## Product Change Notice (PCN)

**PCN Number:** PCN-0450734R-01

Product(s) Affected: *PJ-014CH-SMT-TR*

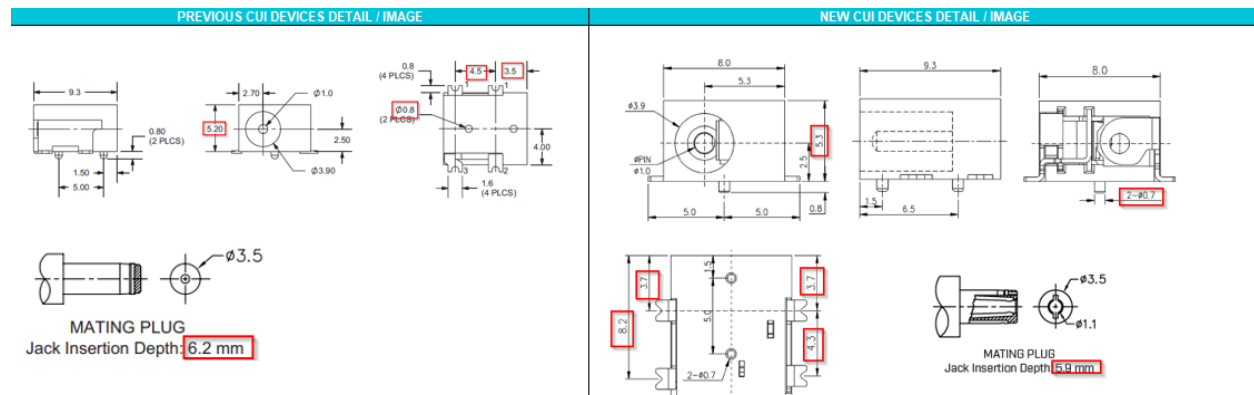
Description of Change: *Mechanical, electrical, and material changes as shown below:*

MATERIAL	PLATING
center pin	copper	nickel
terminal 1	brass	silver
terminal 2	copper alloy	silver
terminal 3	brass	silver
plastic	PA6T or equivalent

DESCRIPTION	MATERIAL	PLATING/COLOR
center pin	brass	silver
terminal 1	brass t=0.50	silver
terminal 2	bronze t=0.25	silver
terminal 3	brass t=0.50	silver
housing	PA1DT (UL94V-0)	black
